Project	<b>IEEE 802.16 Broadband Wireless Access Working Group</b> < <a href="http://ieee802.org/16">http://ieee802.org/16</a> >	
Title	<b>Revision of Hand-over Mechanism for Mobility Enhancement</b>	
Date Submitted	<b>2003-11-7</b>	
Source(s)	Phillip Barber Broadband Mobile Technologies, Inc. 8302 Sebastian Inlet Frisco, Tx 75035	Voice: +1 (972) 365-6314 Fax: +1 (925) 396-0269 <a href="mailto:pbarber@BroadbandMobileTech.com">[mailto:pbarber@BroadbandMobileTech.com]</a>
Re:	Response to IEEE 802.16e-03/23 (Call for Contributions on IEEE 802.16e/07r4)  Response to Session 27 Minutes remand C802.16e-03/54r0 to Ad Hoc Group for refinement and continued revision	
Abstract	Clarification, revision, and definition of Hand-over mechanism for Mobility Enhancements	
Purpose	Stimulate discussion on a more completely defined, flexible model and mechanism for facilitating mobility functionality	
Notice	This document has been prepared to assist IEEE 802.16. It is offered as a basis for discussion and is not binding on the contributing individual(s) or organization(s). The material in this document is subject to change in form and content after further study. The contributor(s) reserve(s) the righ

*[In Annex D.2, page 61, replace **Figure D.10** with:]*

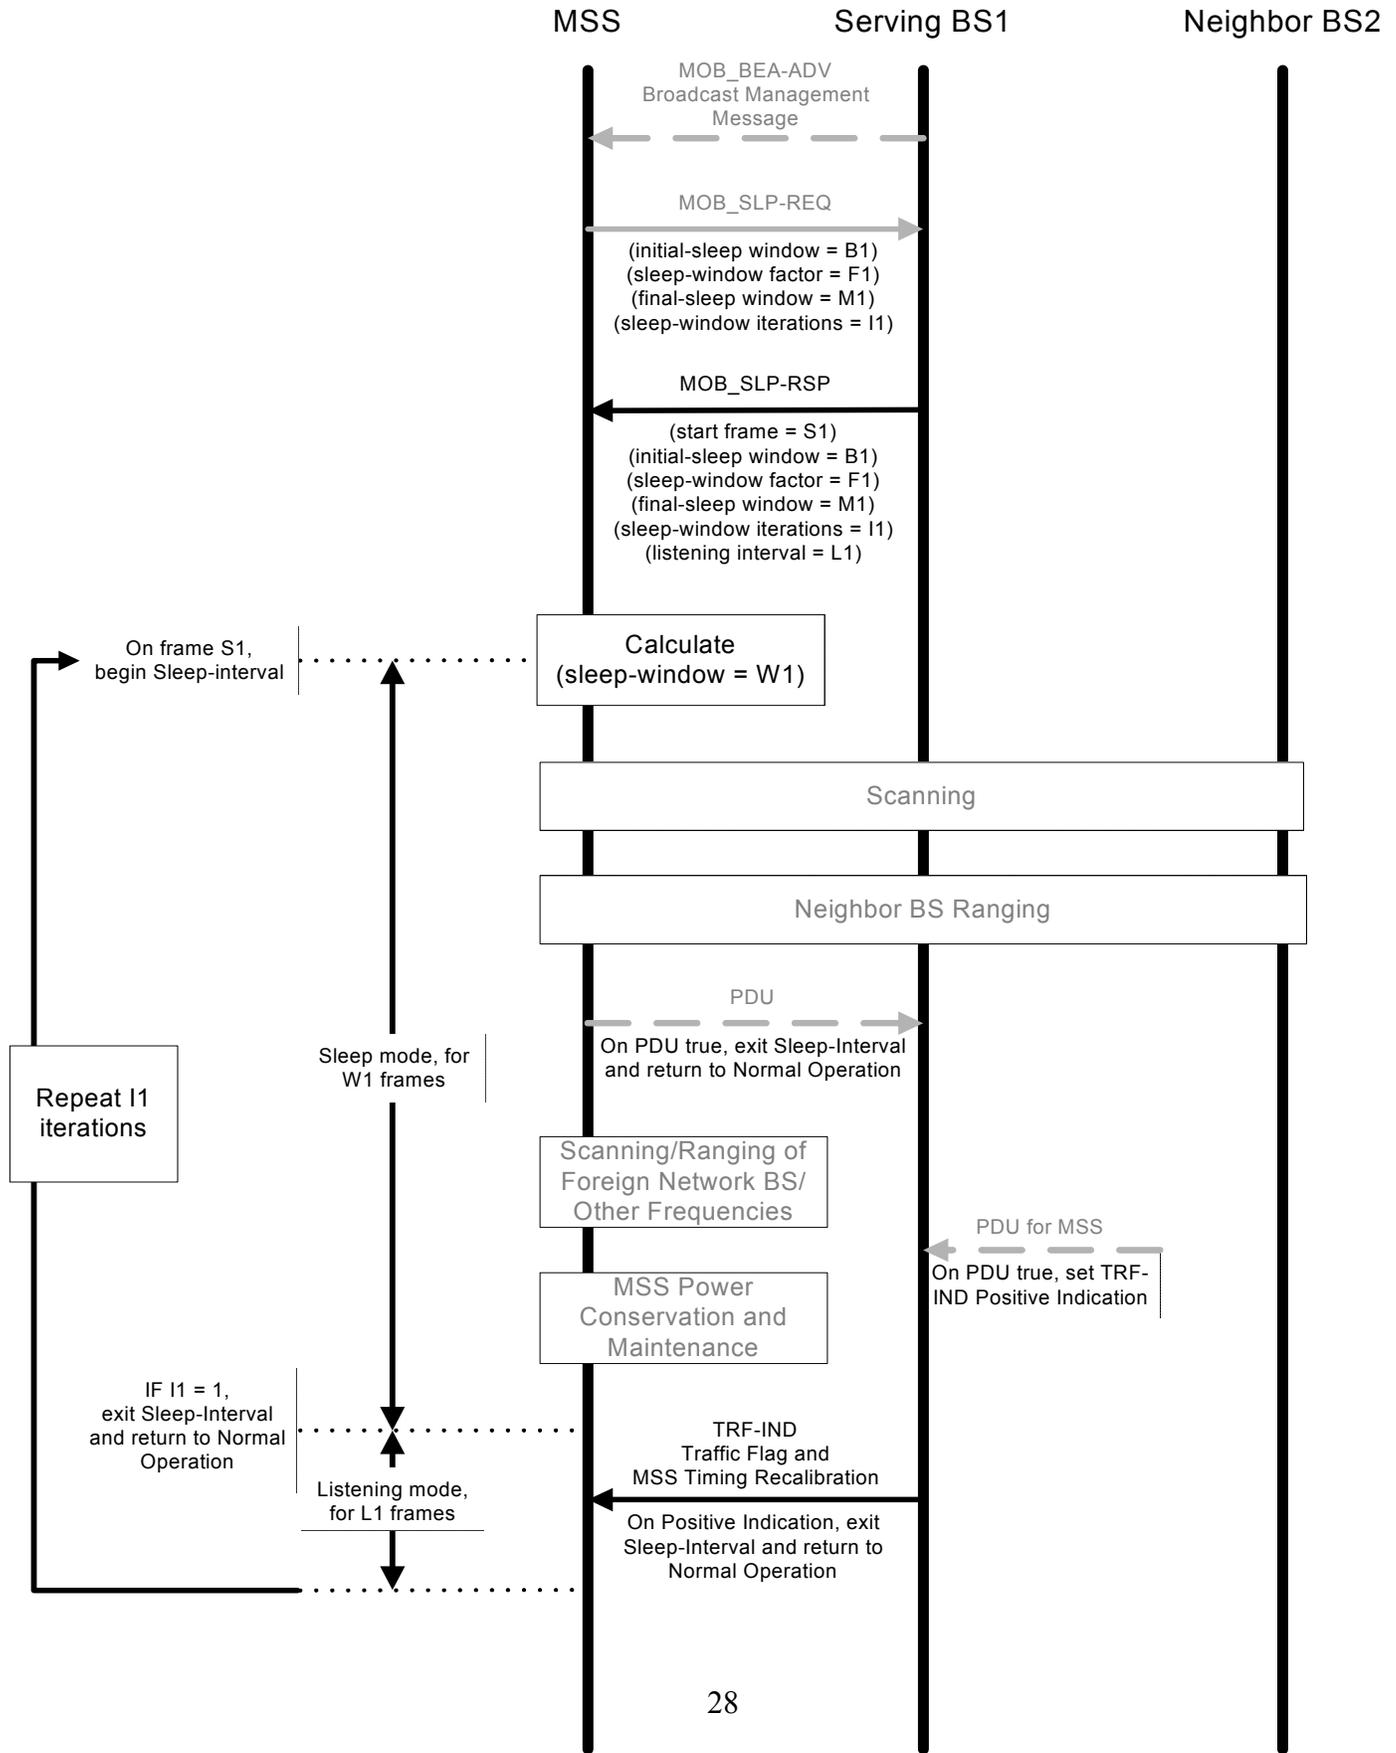
*[In Annex D.2, pages 62 & 63, delete **Figures D.11 and D.12** entirely]*

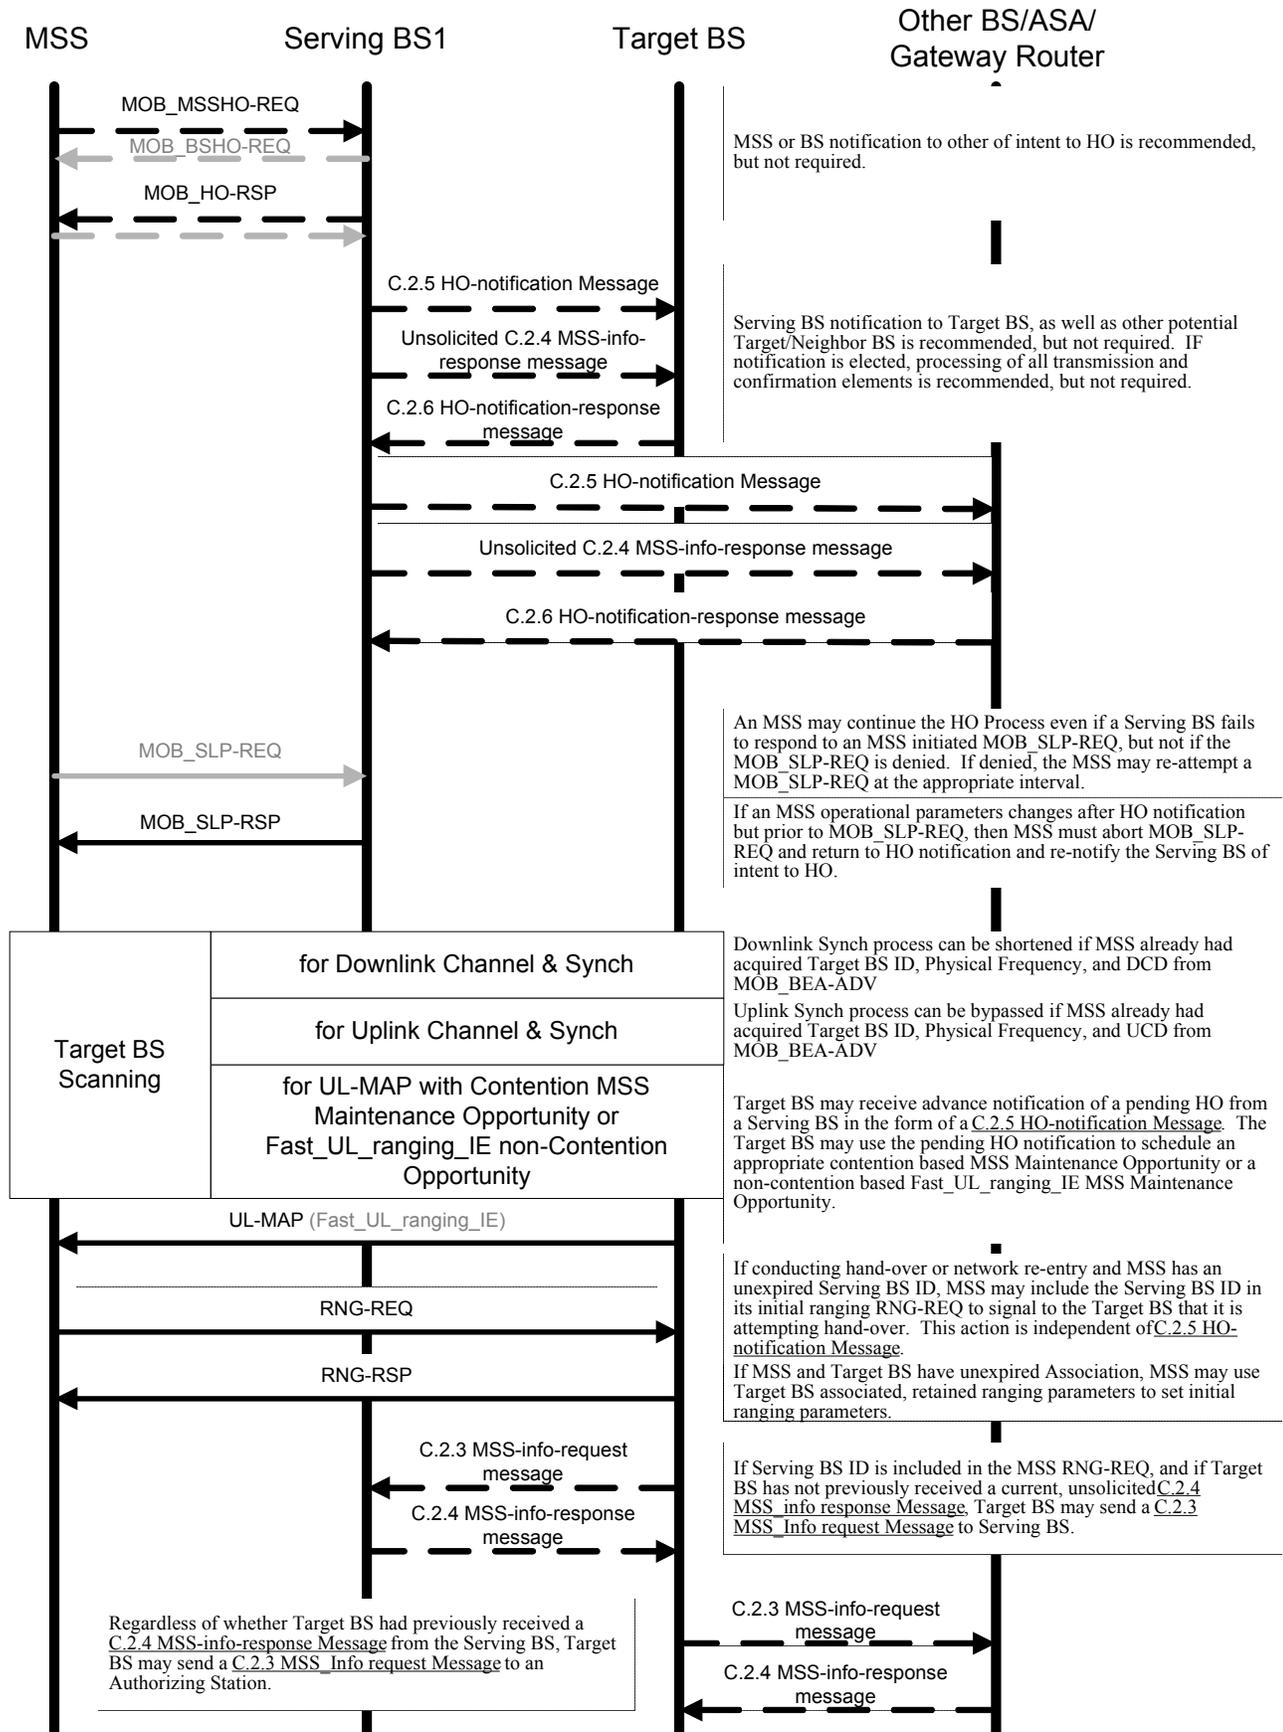
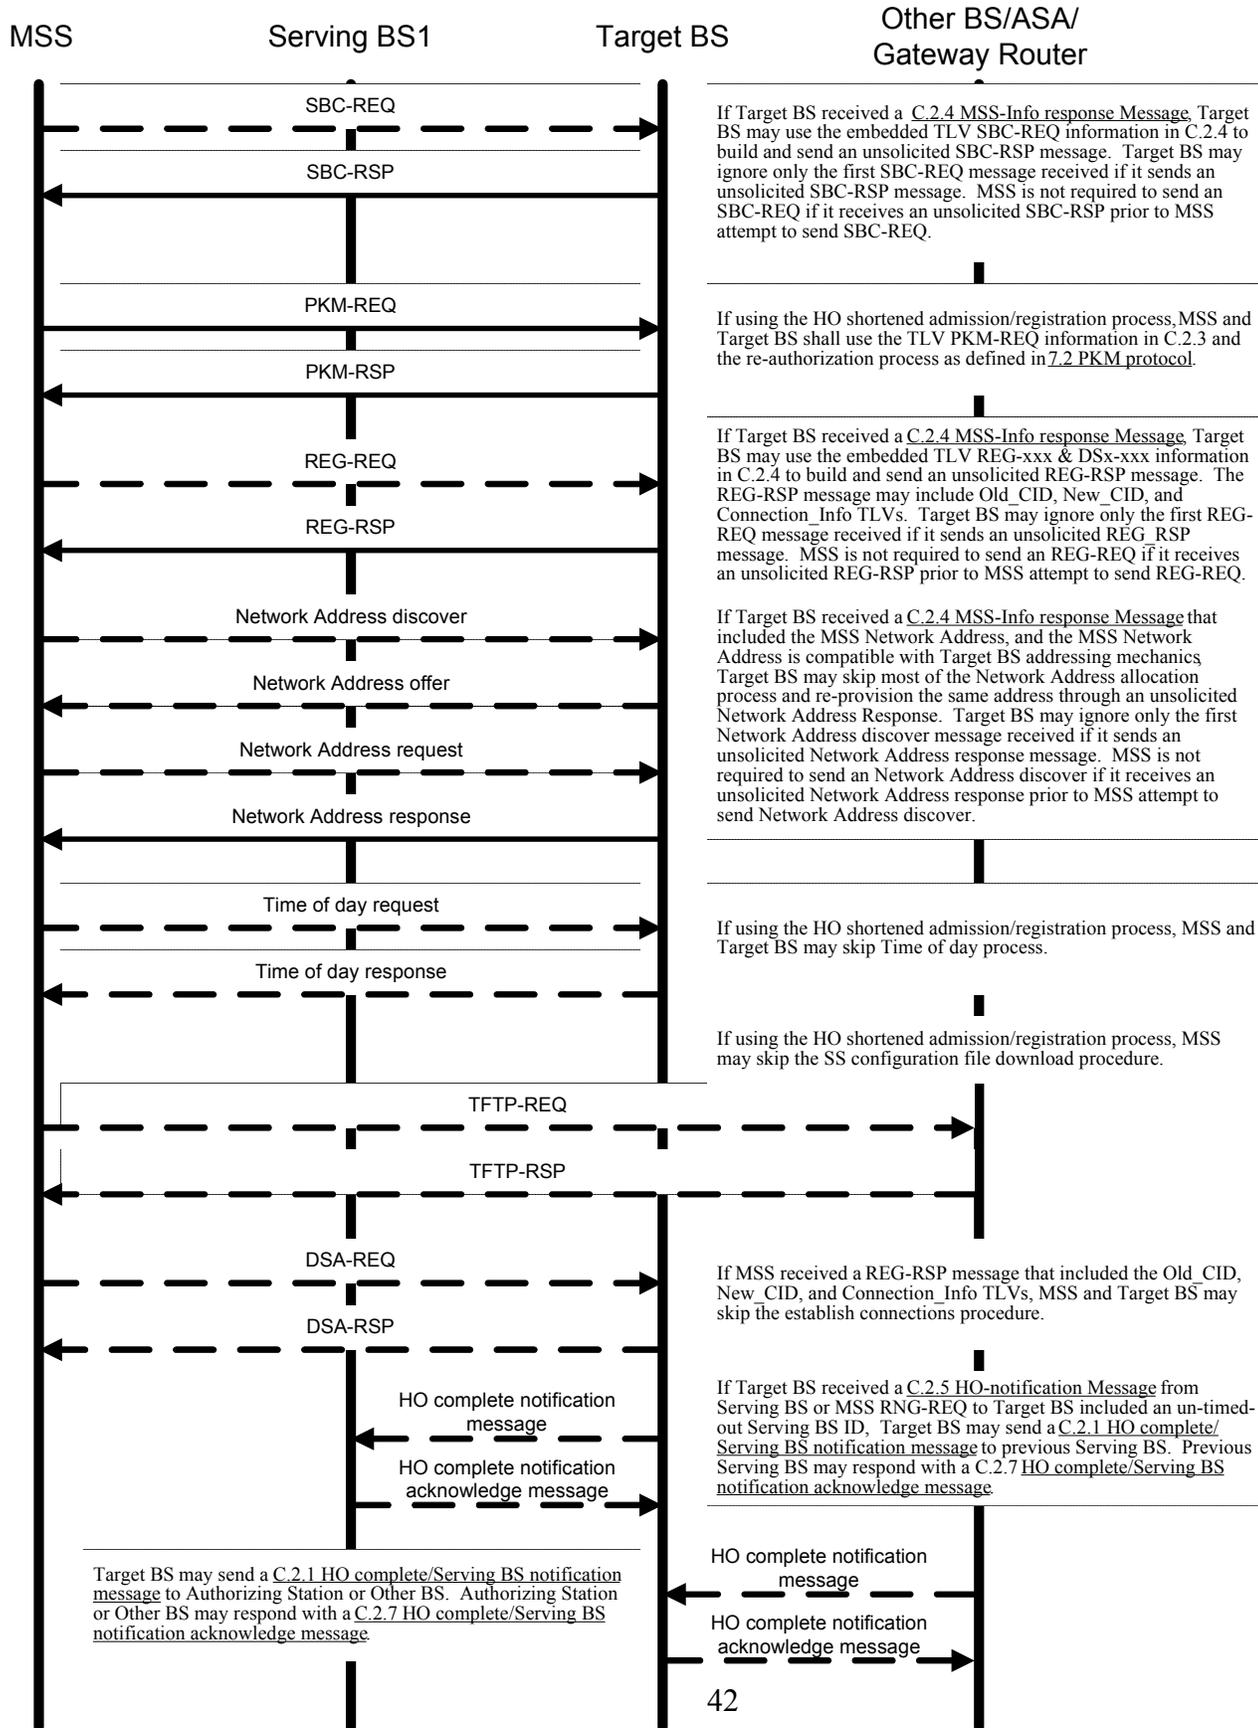
*[In C.2.8 Example of Backbone Network HO procedure, pages 48-50, delete Figure C.2—Example of HO call flow by BS entirely and replace Figure C.1—Example of HO call flow by MS with:]*

**Figure C.1—Example of HO Process Flow**

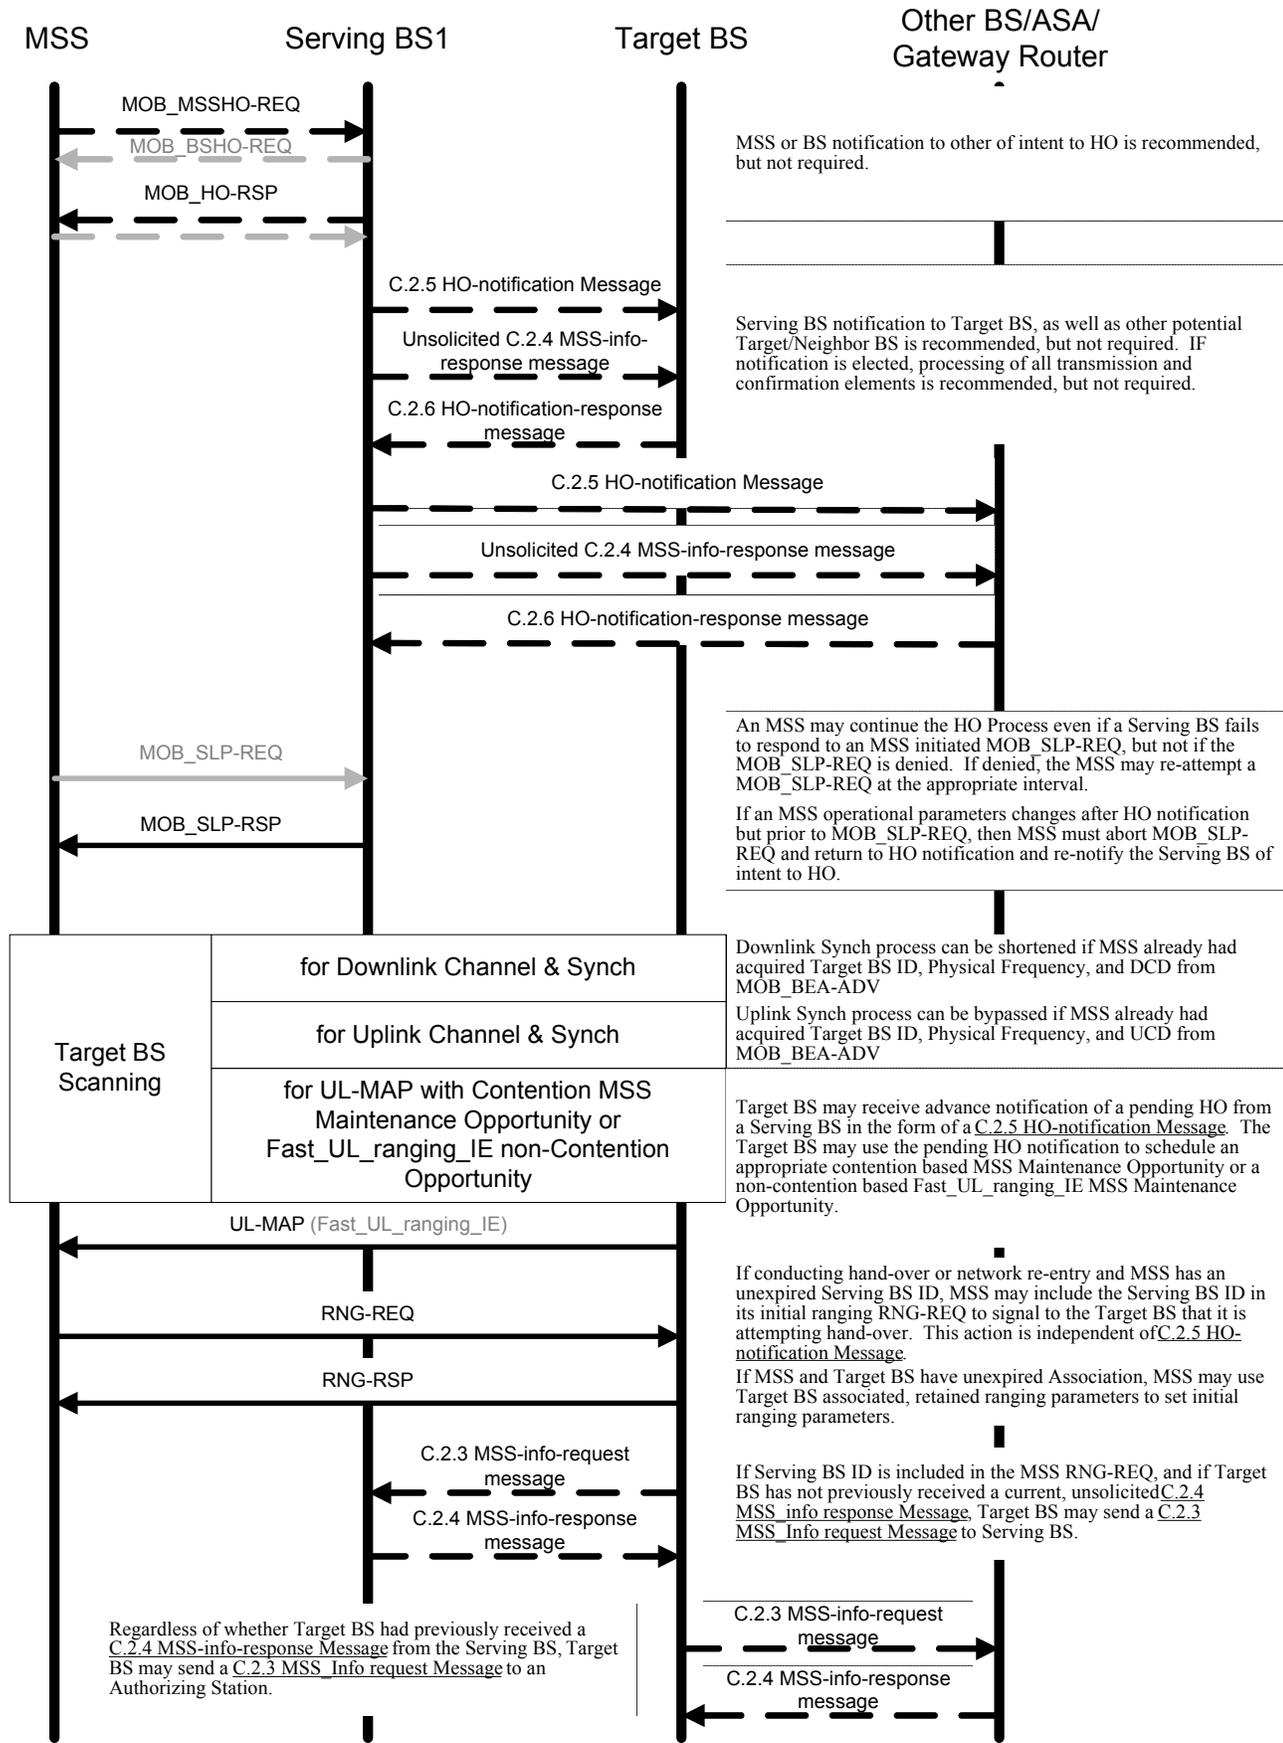
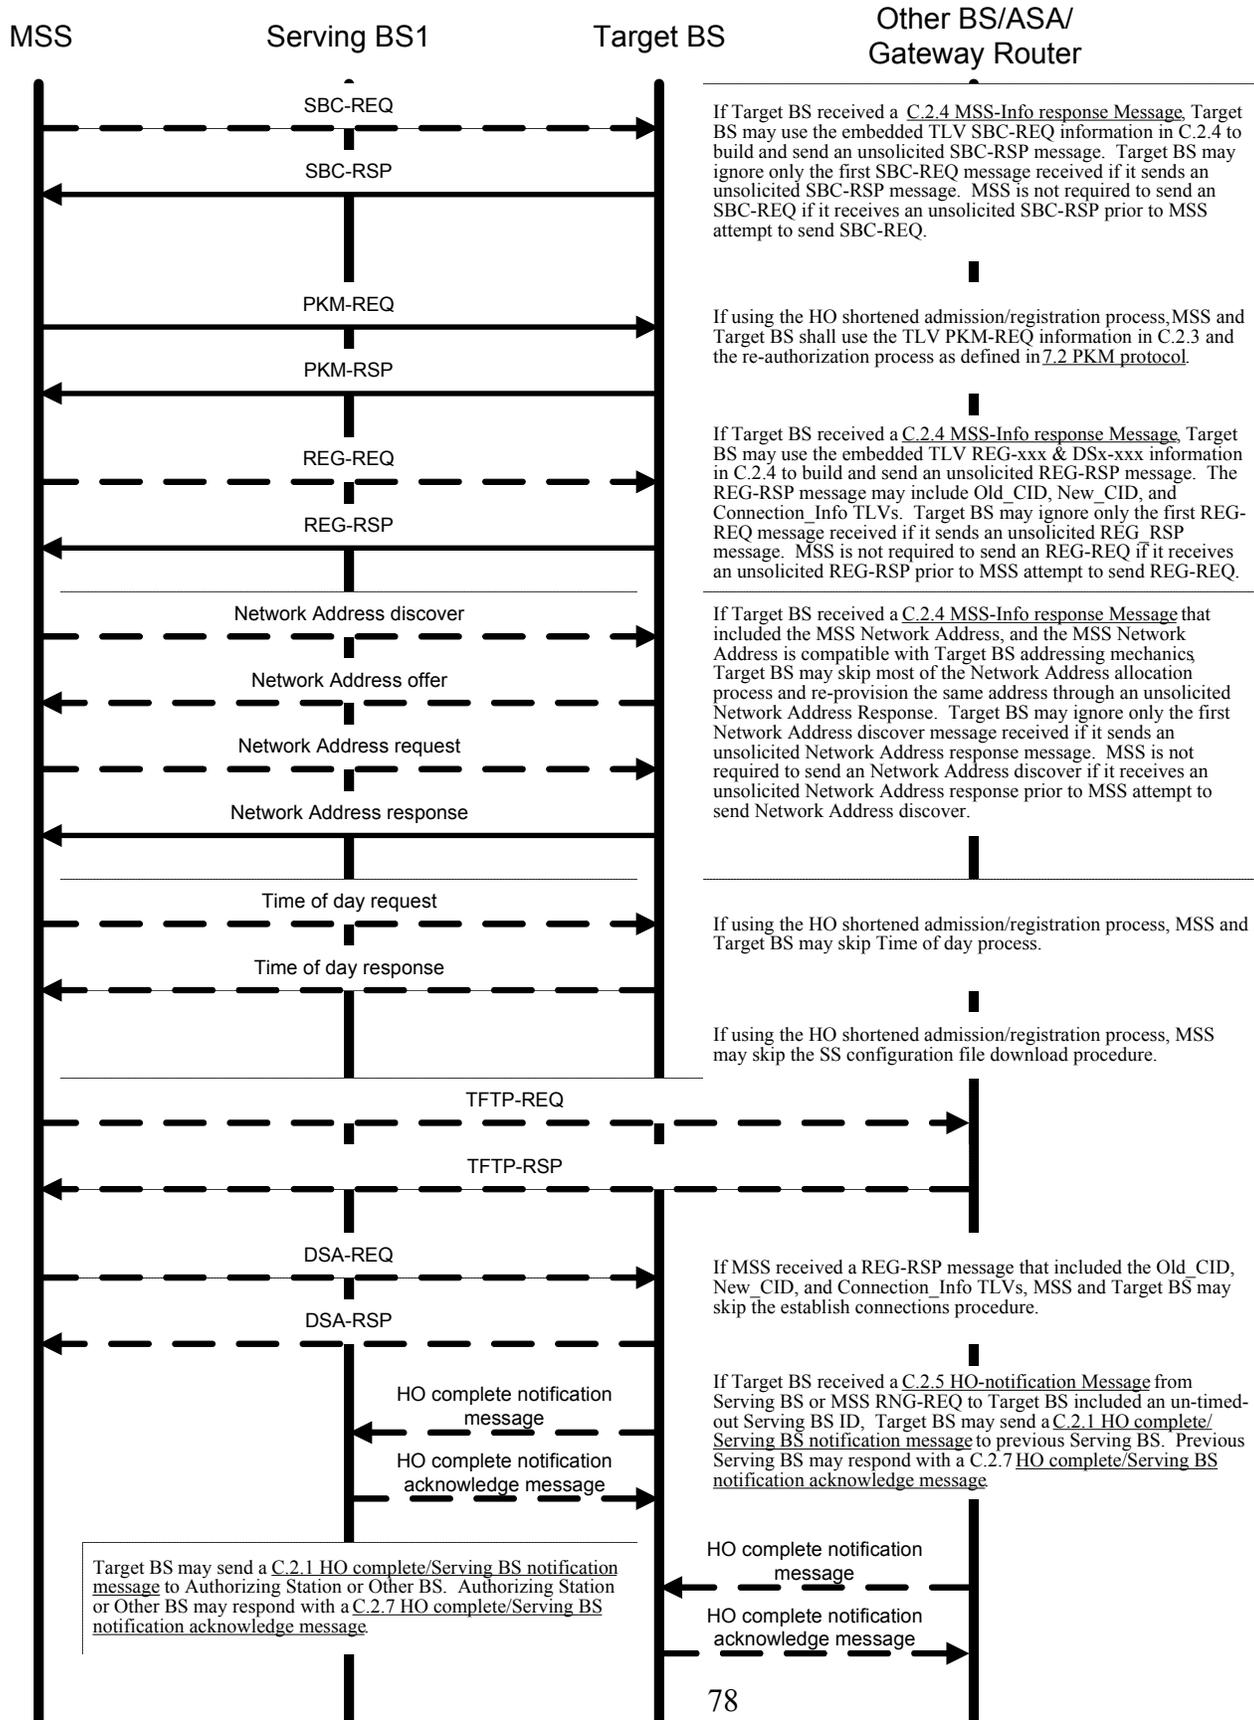
[In C.2.8 Example of Backbone Network HO procedure, pages 48-50, delete Figure C.2—Example of HO call flow by BS entirely and replace Figure C.1—Example of HO call flow by MS with:]
